CITY OF WICHITA

RE: CON2025-00168 –Amend CON2023-00028 to revise site plan for Accessory Apartment, Generally located on the west side of North 63rd Street East and within one-quarter mile north of East 77th Street North (6301 Briar Rose Lane)

RE: CON2025-00168: Administrative Adjustment in the County to revise an approved site plan for CON2023-00028 to change the location of an Accessory Apartment on property zoned RR Rural Residential District; generally located on the west side of North 63rd Street East and one-quarter mile north of East 77th Street North (6301 E. Briar Rose Ln.).

STAFF REPORT

APPROVED MAPC 2/26/26 BY JBE

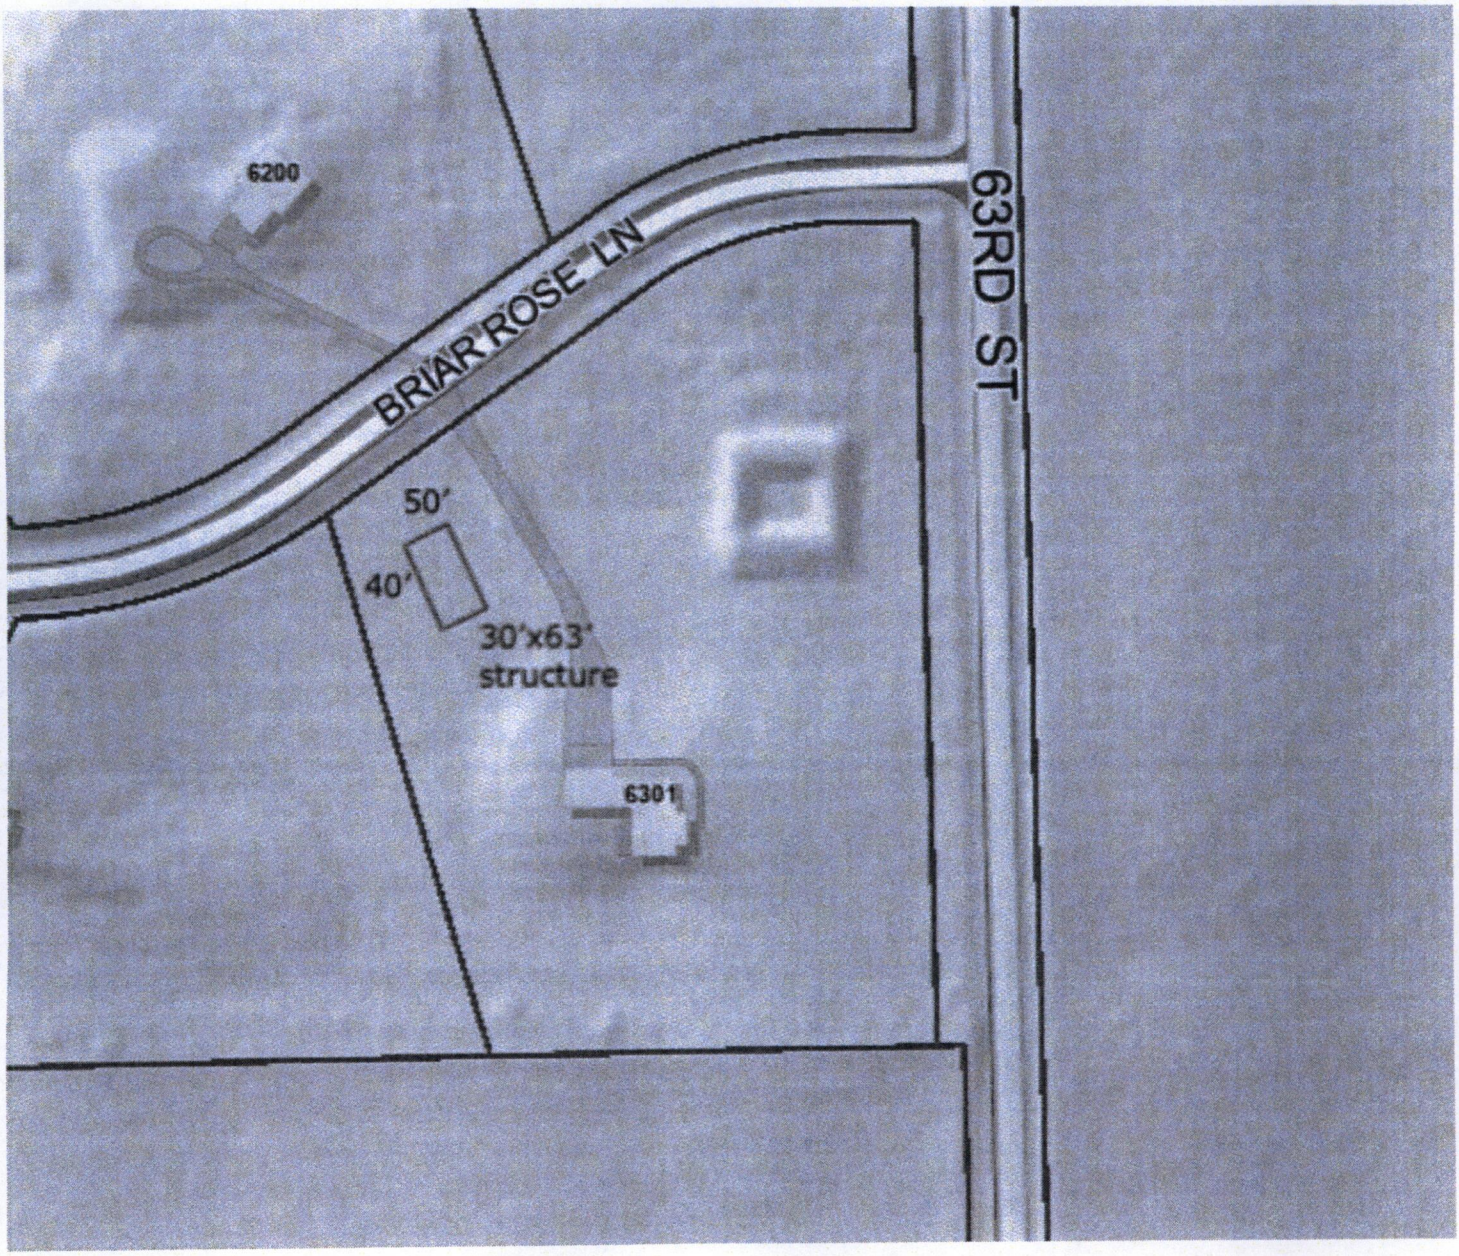
1. The site shall be developed in conformance with the revised site plan.
2. All other approved conditions of CON2023-00028 shall apply.

ORIGINAL SITE PLAN From 7/13/2023 MTG
(ZOOMED IN)

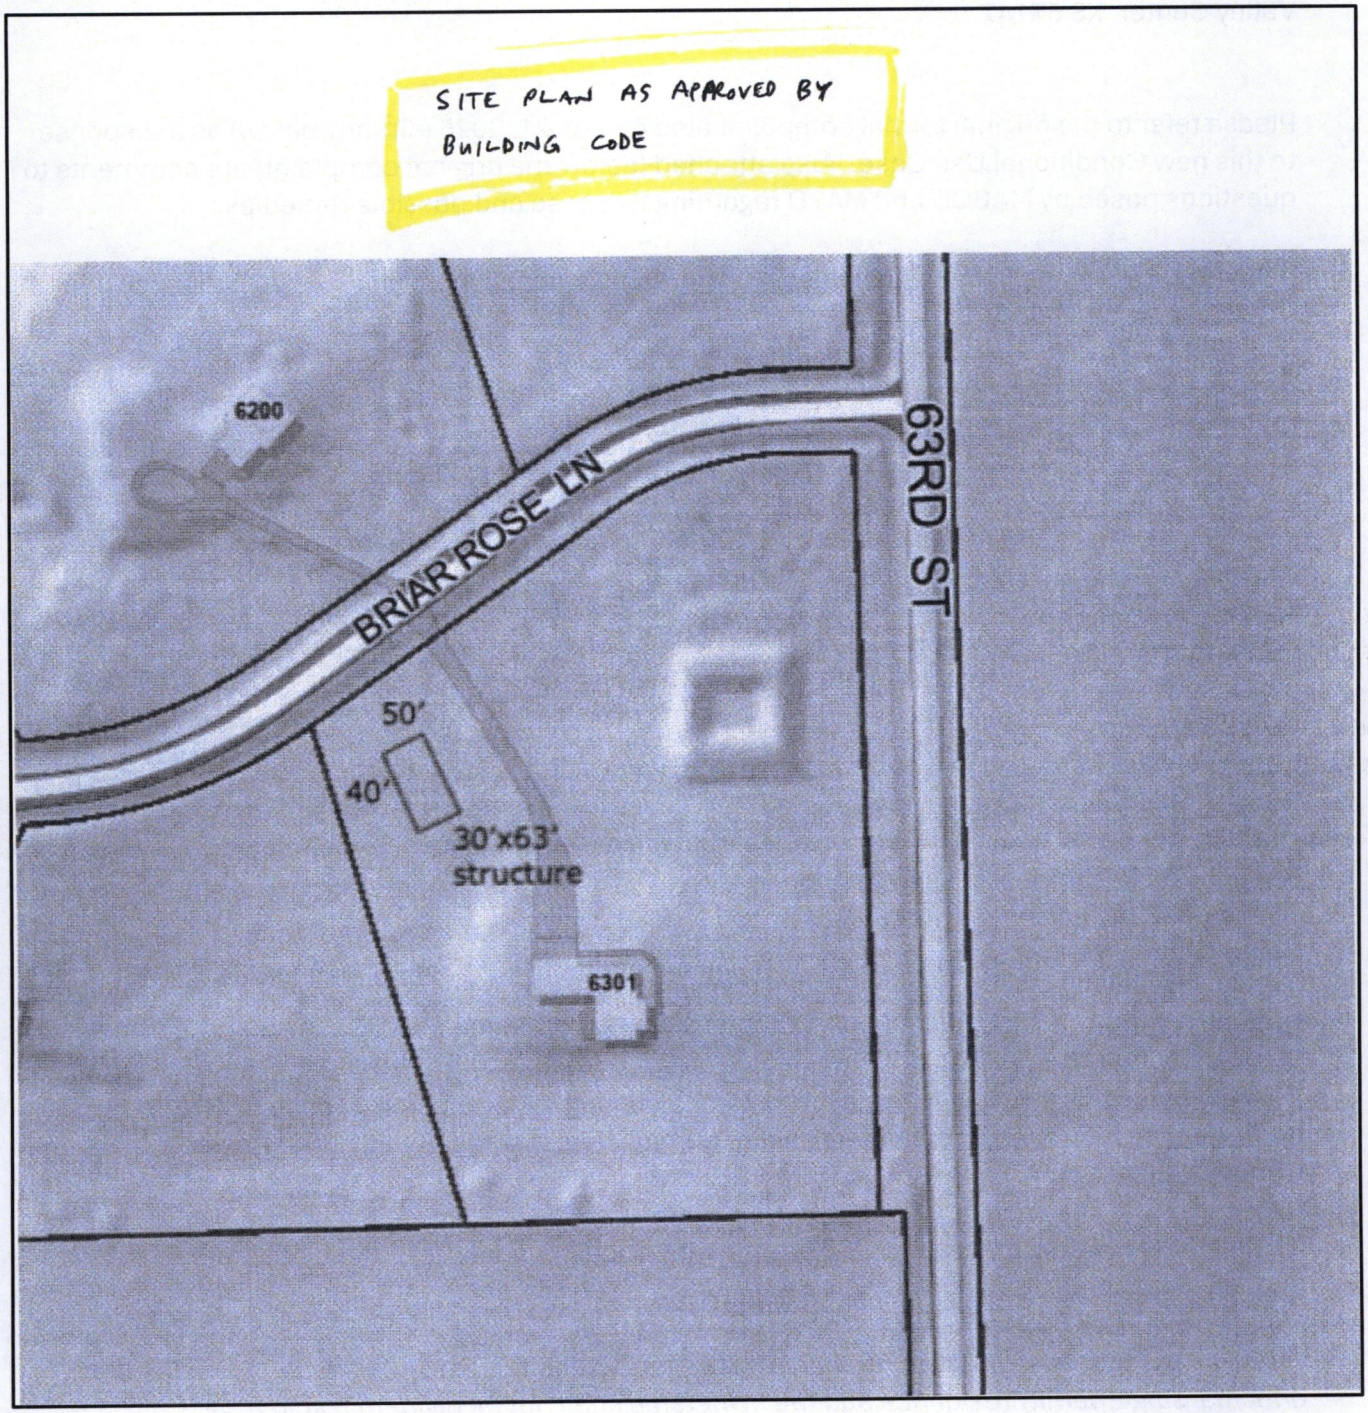
★NOTE THE TOPOGRAPHY LINES SHOWING ELEVATION CHANGE RIGHT WHERE ORIGINAL SITE PLAN LOCATION SHOWED THE STRUCTURE.

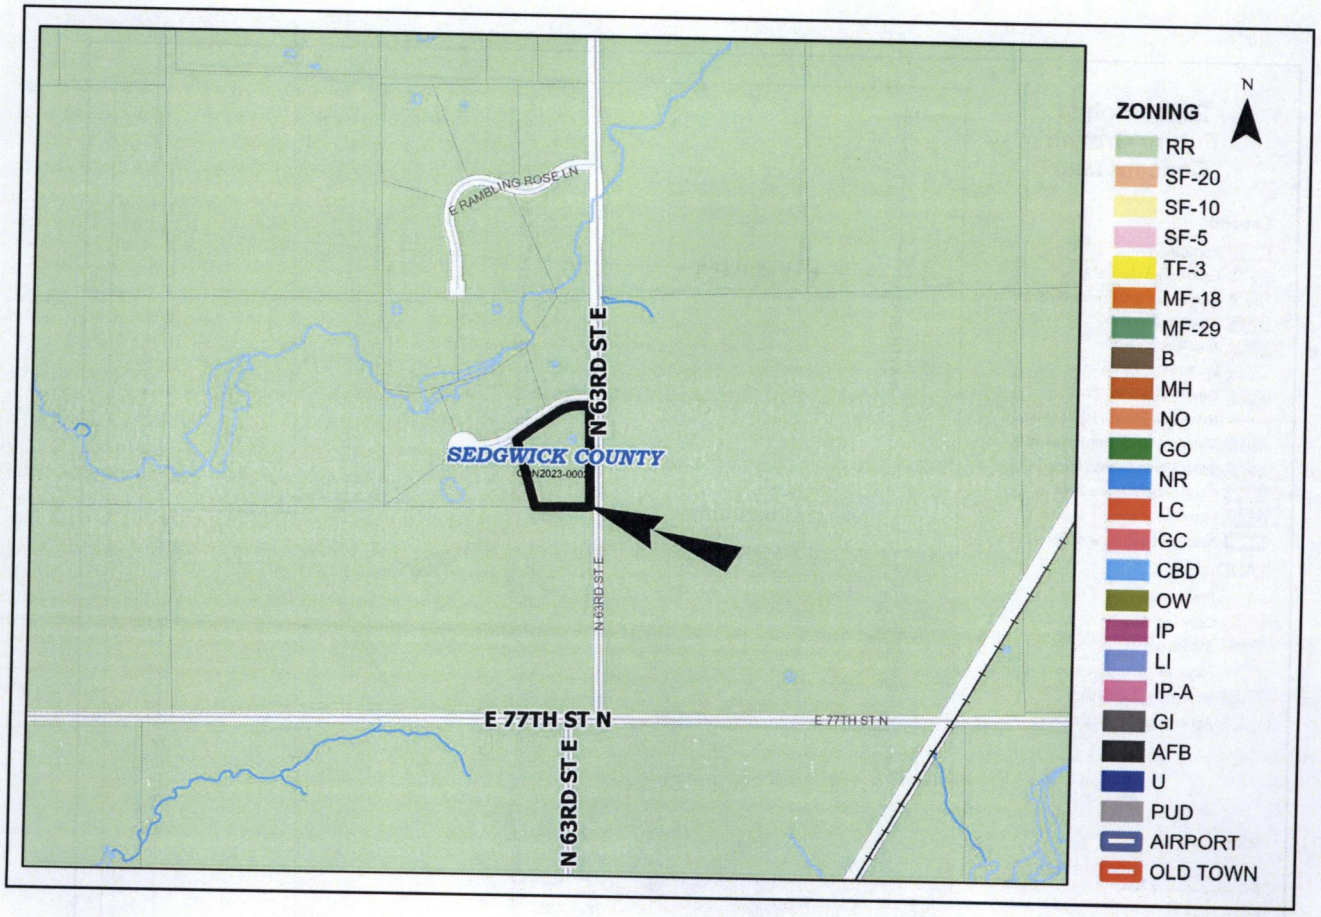
-Sightline landscape screening of Accessory Apartment driveway and garage face from approach both westbound and eastbound on Briar Rose Lane.

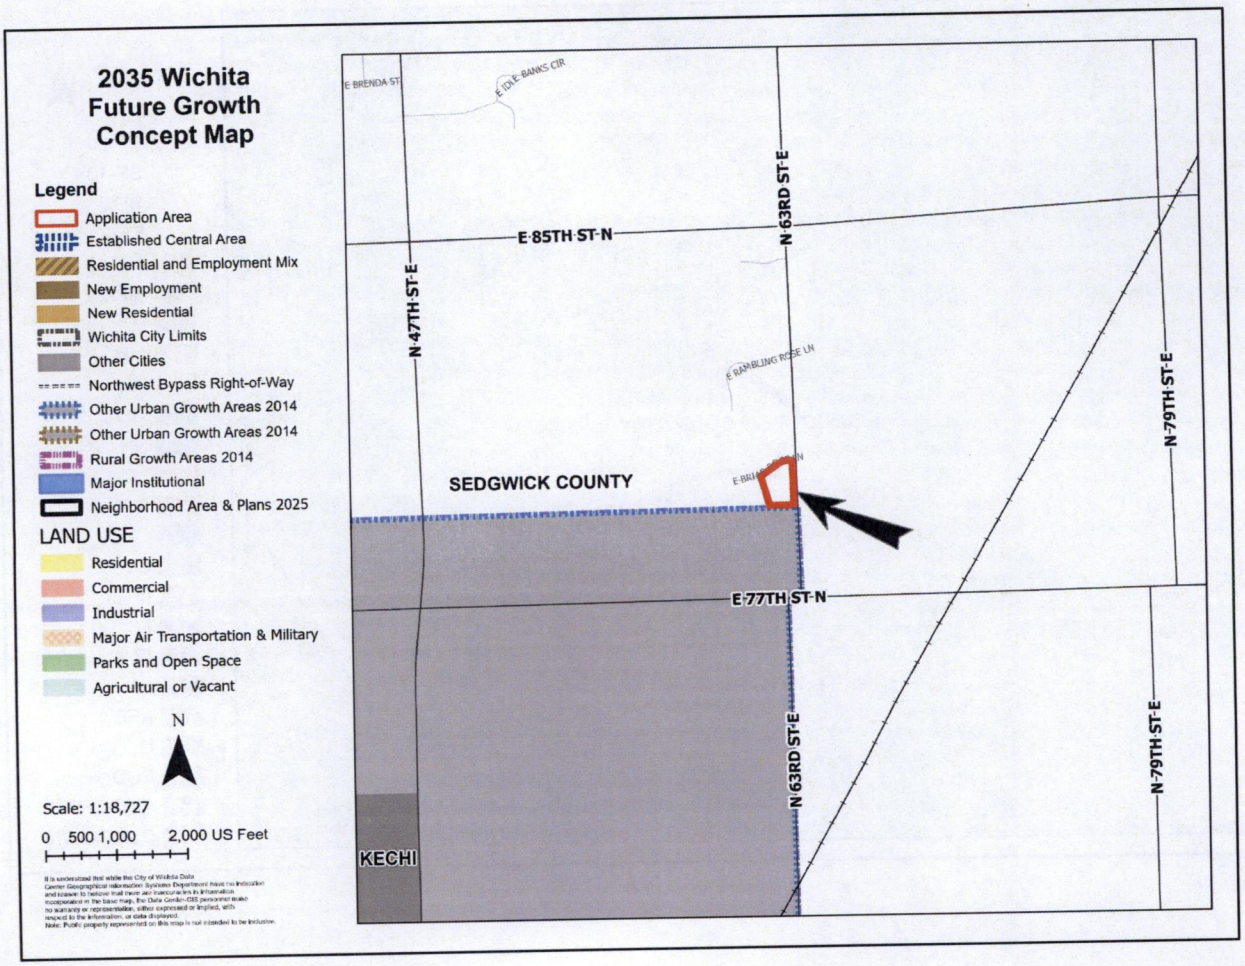
-Sightline landscape screening of Accessory Apartment driveway and garage along the north property line from the main home driveway west, to the northwest corner of the property.

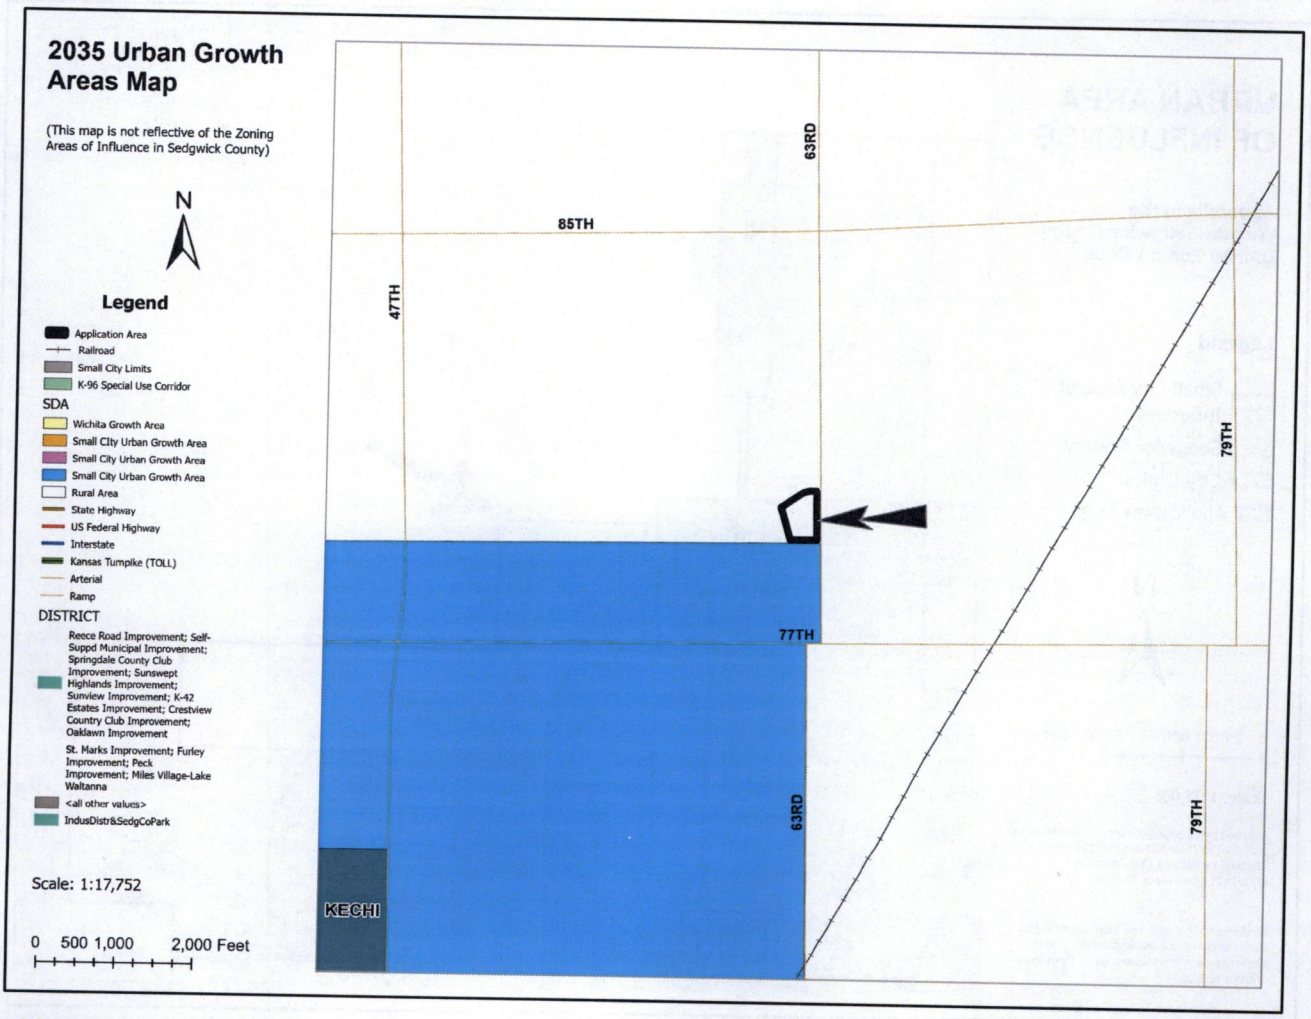
-Sightline landscape screening along the West side of the Accessory Apartment from the northwest property corner, going south, to the southwest corner of the Accessory Apartment site.
